SUBJECT: NEW VEHICLE DEMONSTRATION / DELIVERY HOLD - Safety Recall 17S33 - Supplement #3

Certain 2015-2017 Model Year F-150 and 2017 Model Year F-Super Duty Vehicles
Doors Will Not Close or Open While Driving

New! REASON FOR THIS SUPPLEMENT

Technical Information: Updated with additional robustness actions including the installation of a wiper clip on the exterior door handle cable end and the use of low temperature grease. As a result, the Claims Preparation and Submission, the Labor Allowances and the Parts Requirements / Ordering Information have also been updated.

FIGURE 14a

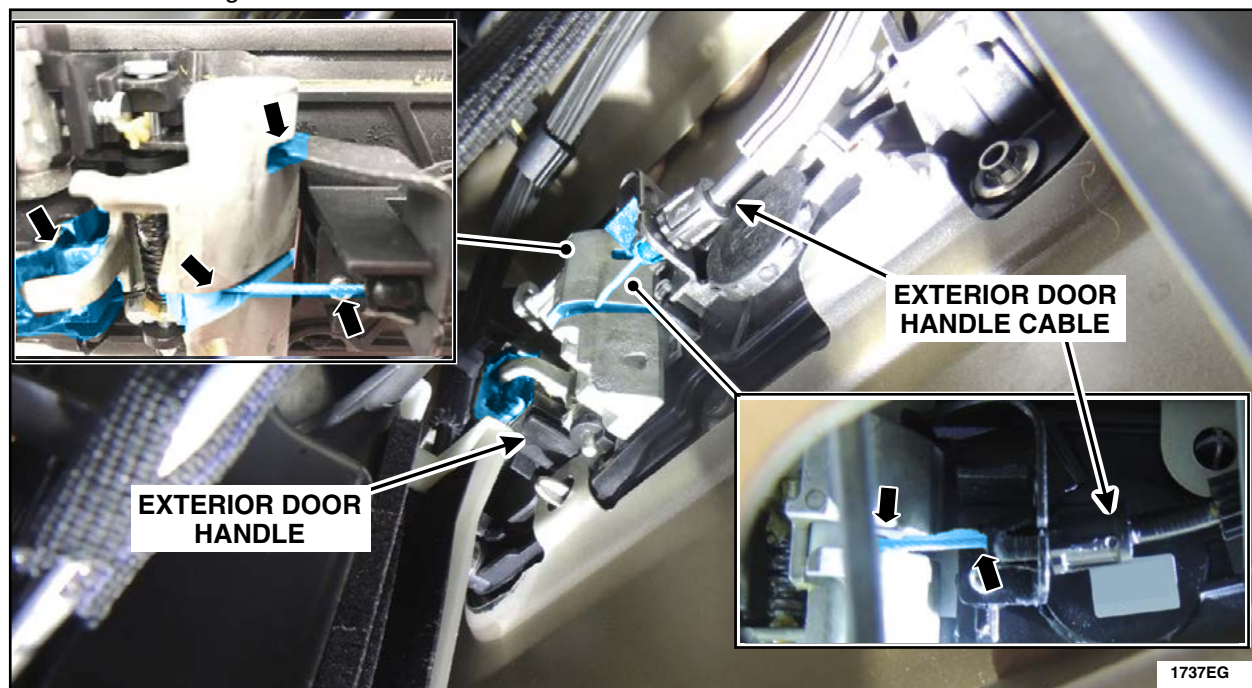
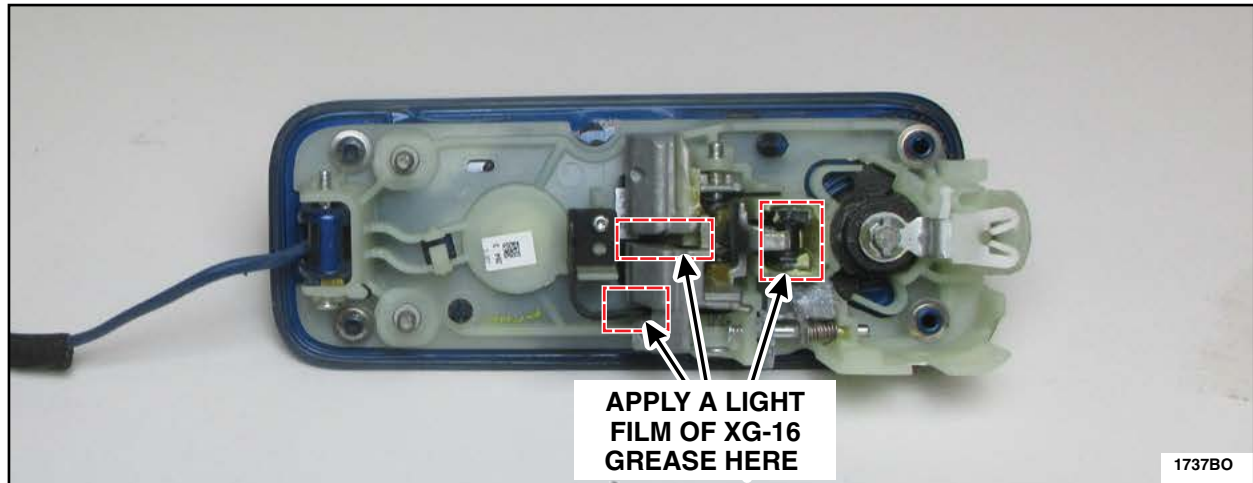
19. Through the large door sheet metal opening, use a brush to apply a light film of Motorcraft® *low temperature* **XG-16** grease to the exterior door handle cable end, and to the three additional highlighted areas. See Figures 14a and 14b.

FIGURE 28a

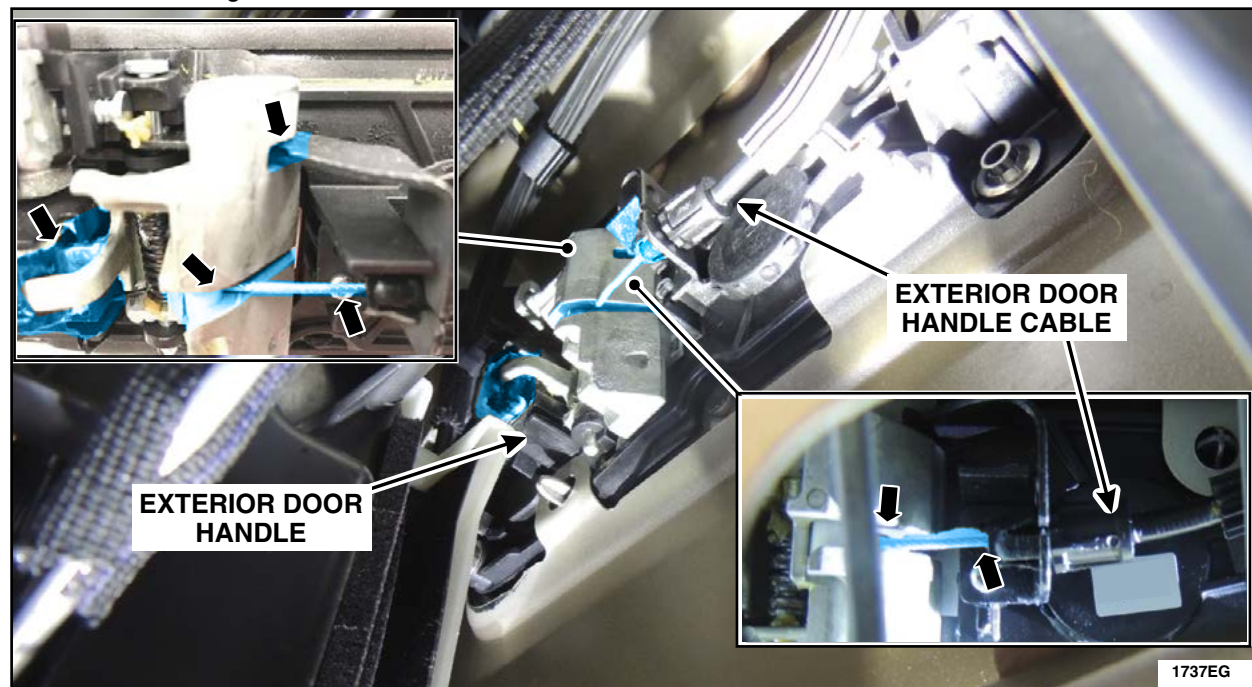
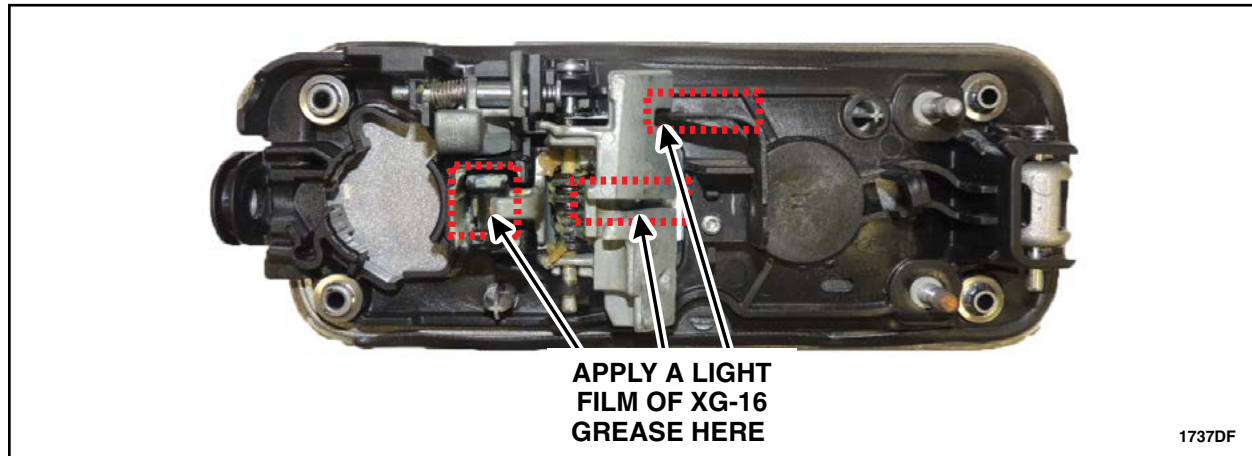
13. Through the large door sheet metal opening, use a brush to apply a light film of Motorcraft® *XG-16 low temperature* grease to the exterior door handle cable end, and to the three additional highlighted areas. See Figures 28a and 28b.
